**NEI 99-02 FAQ 19-02 - Final Response  
Brunswick RCS Leakage**

Plant: Brunswick Nuclear Power Plant Unit 1

Performance Indicator: BI02 - Reactor Coolant System Leakage

Figure 1, RCS Leak location

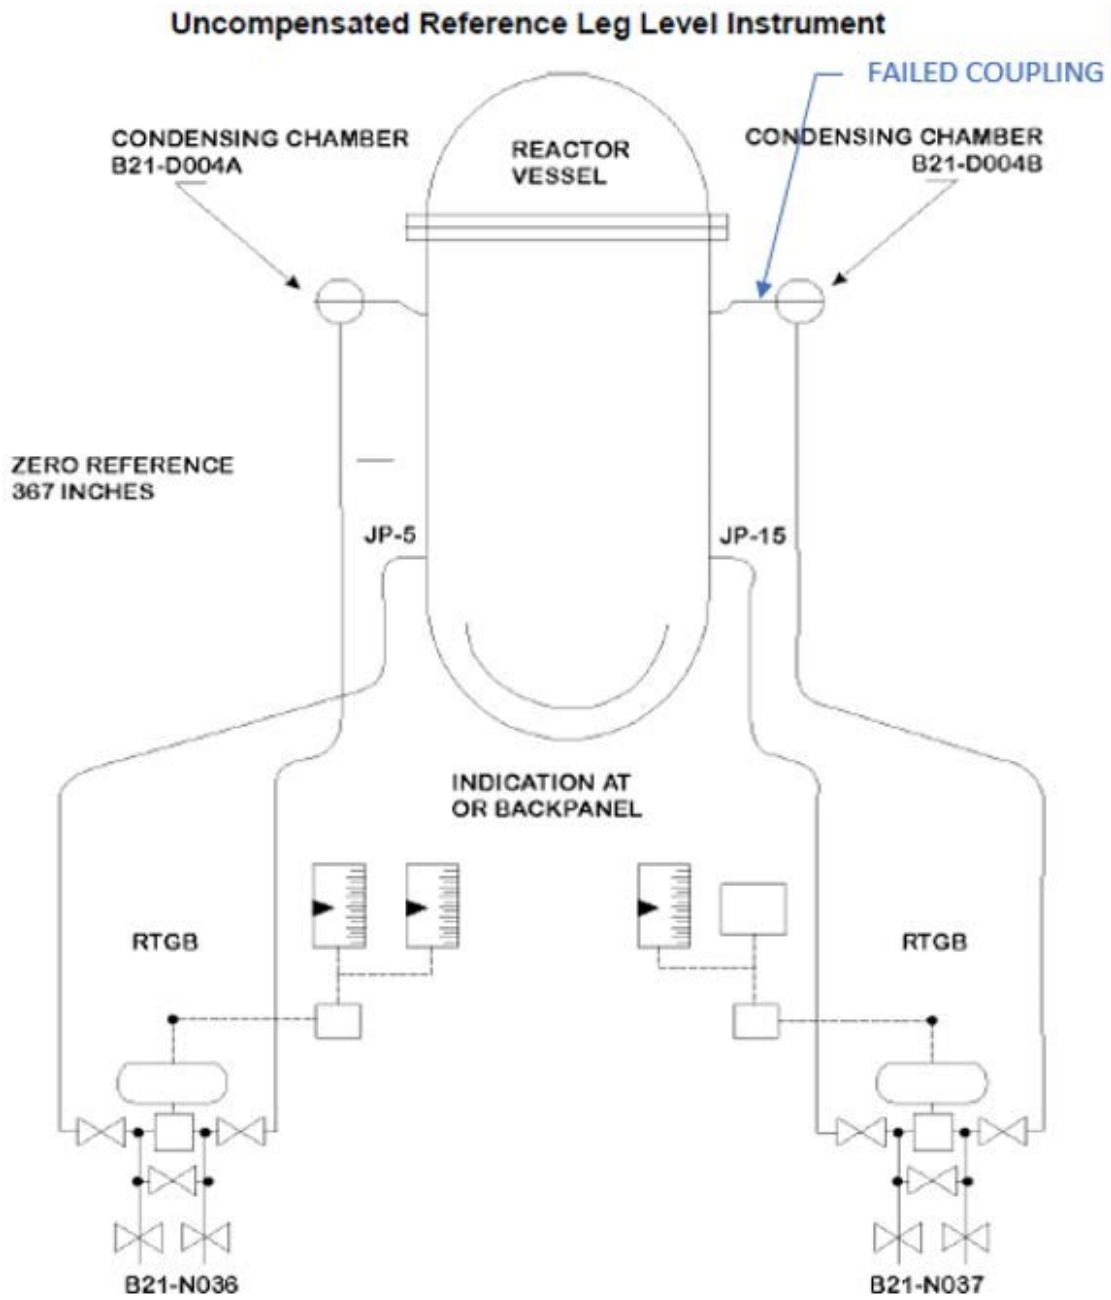
Investigation inside containment determined that a 1-inch coupling on line 1-B21-774 located on the steam side of a reactor level condensing chamber experienced a 360° circumferential separation at the approximate center of the coupling as shown in Figures 1 and 2 below. This opened a path for steam from the reactor to leak into the drywell. Reactor water level was maintained in the established level band, below the level of the sensing line nozzle, throughout the event. The impact from the coupling failure has been analyzed by the Duke Probabilistic Risk Assessment staff and determined to be very low safety significance.

An evaluation was performed to address the couplings installed in both units. All couplings exposed to reactor steam (i.e., potentially susceptible) were removed and replaced with welded fittings prior to startup of Units 1 and 2. In addition, the installation procedure for the couplings was placed on hold pending revision, to prevent any further installation of Cryofit couplings.

Figure 3, March 2019 Reported RCS Leakage (4-hour periodicity)

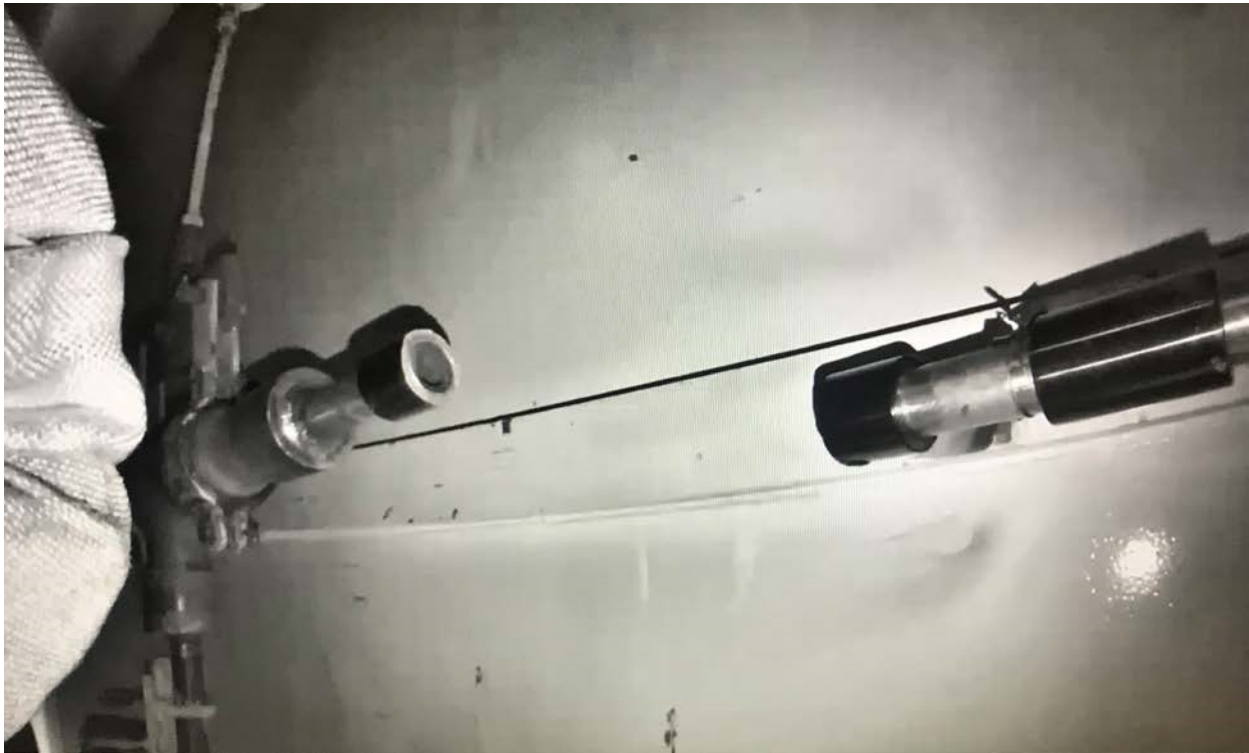
The PI is intended to monitor leak-before-break situations that are viewed as precursors of a more catastrophic failure. In the Brunswick event, RCS Total leakage had been steady for the month of March as shown below in Figure 3. There was no advanced indications of degradation or leakage from the coupling and no trend that worsened over time due to operator inaction.

As shown in Figure 3, RCS Leakage trends were stable and low in the Green performance band for the month leading up to the coupling failure. The coupling failure occurred without warning. Drywell leakage and temperature in the vicinity of the coupling did not increase prior to the failure. There was no opportunity for Operations staff to identify this condition in advance of failure. As no precursors were present, no mitigating actions could have been taken in advance of the leak and the actions taken following the leak indicate prompt and conservative response on the part of the licensee. In addition, the location of the leak prevented it from being isolated until the plant was depressurized, which added to the volume of the leakage calculated in the PI. Despite timely operator actions to accomplish this, the volume of leakage calculated in the PI resulted in one calculation data point exceeding the threshold for White. The degradation mechanism of the coupling will be evaluated under other NRC processes.
